Access Compliance Report

Public Rights-of-Way

(Curb Ramps)

Intersection ID: 14214	Main Street: E_PARK_AV	Cross Street: MYRTLE_AV	Location: SE
ADA ID: B9C74F3A4641	Ramp Type: PerpDiag	Initial Pass/Fail: Fail	Overall Compliance: No
Codes/Mitigation Info/Possible Solution			Severity Score: 35
			Field Measurements/Component Compliance

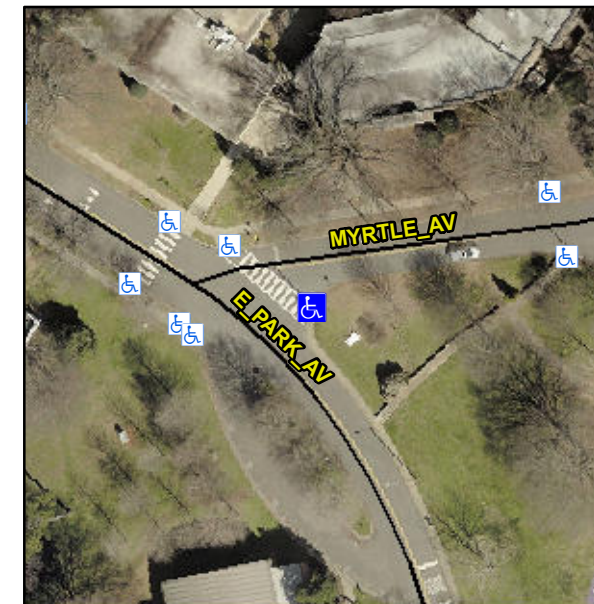
Not Found, R304.5.1, R304.2.2, R304.5.3

Compliance	Description	Data	Compliance	Description	Data
N/A	Ramp Length (in)	39.0	No	Ramp Slope (%)	12.8
No	Ramp Width (in)	46.0	No	Ramp XSlope (%)	4.3
N/A	Flare Type LT	N/A	N/A	Flare Type RT	N/A
N/A	Flare Slope LT (%)	N/A	N/A	Flare Slope RT (%)	N/A
N/A	Flare Traversable LT?	N/A	N/A	Flare Traversable RT?	N/A
N/A	Landing Length (in)	N/A	N/A	DWS Provided?	N/A
N/A	Landing Width (in)	N/A	N/A	DWS Contrast?	N/A
N/A	Landing Slope (%)	N/A	N/A	DWS Length (in)	N/A
N/A	Landing X Slope (%)	N/A	N/A	DWS Full Width?	N/A
N/A	Landing Curb? (Y/N)	N/A	N/A	DWS Offset (in)	N/A
N/A	Shared Landing?	N/A			
N/A	Gutter Ponding?	N/A	N/A	Gutter Slope (%)	N/A
N/A	Gutter Lip Ht (in)	N/A	N/A	Gutter X Slope (%)	N/A
N/A	Painted X Walk1?	Yes	N/A	Painted X Walk2?	No
	X Walk 1 Direction	To NW		X Walk 2 Direction	To W
N/A	X Walk 1 Width (in)	108.0	N/A	X Walk 2 Width (in)	N/A
	X Walk 1 Slope (%)	9.6		X Walk 2 Slope (%)	1.5
	X Walk 1 X Slope (%)	5.8		X Walk 2 X Slope (%)	6.0

N/A	Ramp inside XWalk1?	Yes	N/A	Ramp inside XWalk2?	N/A
	Road Slope (%)	0.4	N/A	Clear Space?	N/A
	Road X Slope (%)	12.4	N/A	Clear Space to XWalk (in)	N/A
N/A	Any Obstructions?	N/A	N/A	Storm Grate/Utility Hazard?	N/A
	Obstruction Type			Storm Grate/Utility Type	
		N/A			N/A
		Yes		Surface Condition? (G/P)	Good

Possible Solutions:

Remove & Replace Curb Ramp With Two New Directional Ramps or Equivalent.
